Item No. 9.1.2
Design Review Committee
September 9, 2021

SUBJECT: **Case 23726: Substantive Site Plan Approval – 1470 Queen Street, Halifax**

1. Approve the qualitative elements of the substantive site plan approval application for an 8-storey mixed-use building on lands at 1470 Queen Street, Halifax (PID 00077461), as shown in Attachment A;
2. Approve the variances to the Land Use By-law requirements regarding minimum streetwall width, internal property line setbacks above the streetwall, maximum and minimum streetwall heights and upper storey streetwall stepbacks, as contained in Attachment B;
3. Accept the findings of the quantitative Wind Impact Assessment, as contained in Attachment C; and
4. Recommend that the Development Officer accept the undergrounding of electrical and communication distribution systems (underground vault for utilities) as the post-bonus public benefit category.

Figure 4: Illustration of required balcony encroachment variance for angular plane encroachment. View from eastern face of building. See sheet A1.14 – Main Building Section in Architectural Building Package for full image.

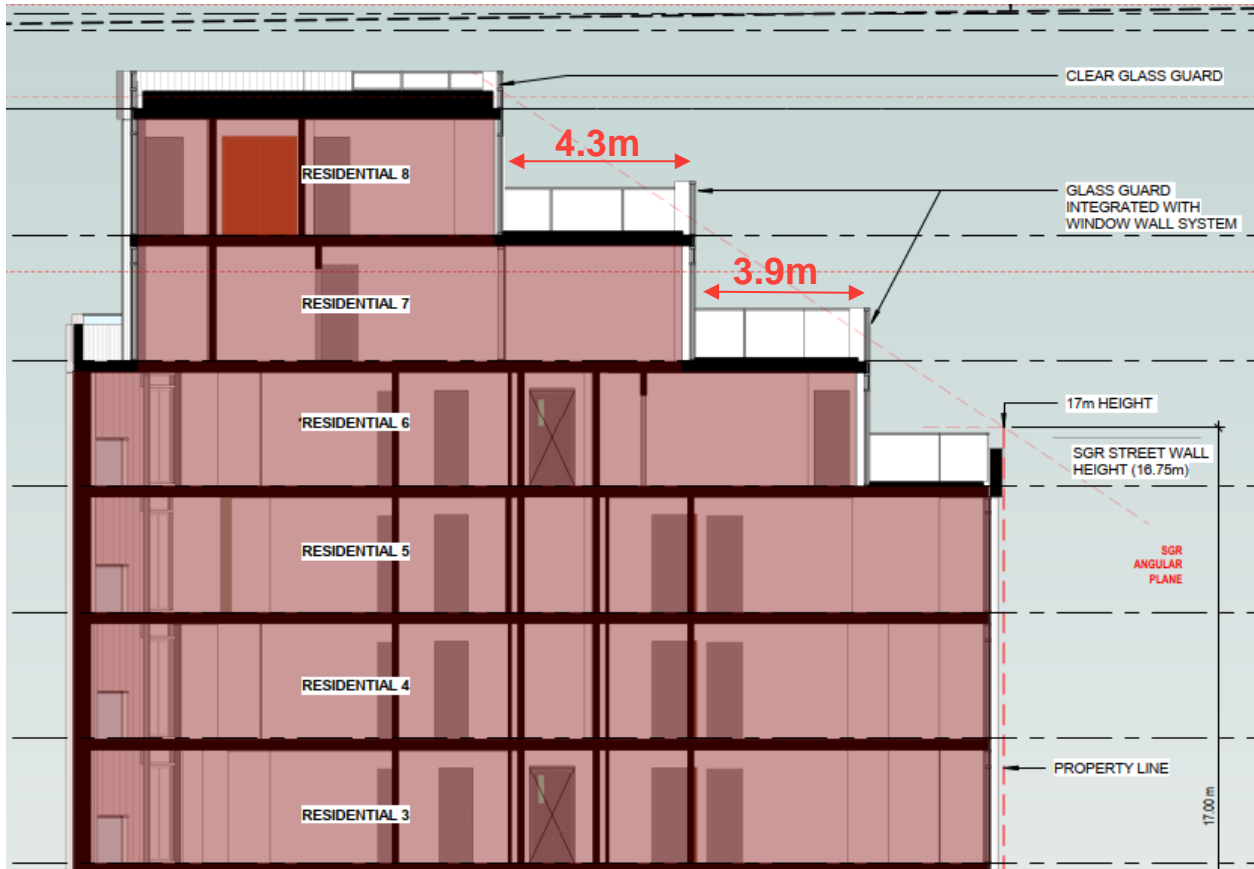
This variance is to provide for a deeper balcony from the building (4.3m and 3.9m), and to have an aggregate length of 100% of the northern building face which the balcony occupies.

VARIANCE CRITERIA	RATIONALE
<i>Upper storey streetwall stepbacks may be varied by Site Plan Approval where:</i>	--
<i>a. the modified setback is consistent with the objectives and guidelines of the Design Manual; and</i>	a. The upper portion of the building is consistent with the Design Manual as described in Section 2 of this application letter. The balcony terraces located at the upper and middle part of the building facing Spring Garden Road provide smooth horizontal lines that unify the building’s façade into a modern and cohesive design.
<i>b. the modification results in a positive benefit such as improved heritage preservation or the remediation of an existing blank building wall.</i>	b. the requested variance provides a positive benefit to the building’s overall design, particularly in the middle and upper portions of the building. While there are intended vertical breaks carried throughout the northern façade, these upper terraces provide a smooth unifying feature which really work to bring the whole building (horizontally and vertically) together. Additionally, having deeper balconies (greater than 2m) along the middle and upper portions of the building provides more morning sunlight penetration on to the street. The variance is for the balconies to be set back deeper than the permitted 2 m. In doing this, a more generous balcony space is possible, which allows for more vibrancy along Spring Garden, rather than having this space filled with building roof structure (which would otherwise be the case due to the terracing required on this building face to meet the Spring Garden Road angular plane. By requiring a maximum 50% aggregate length, the building loses that unifying feature and results in a broken up look which detracts the look and feel of the Spring Garden Road façade. Having 100% aggregate length allows for the building to provide a consistent and cohesive building design which complements the frequent vertical breaks in the northern façade.
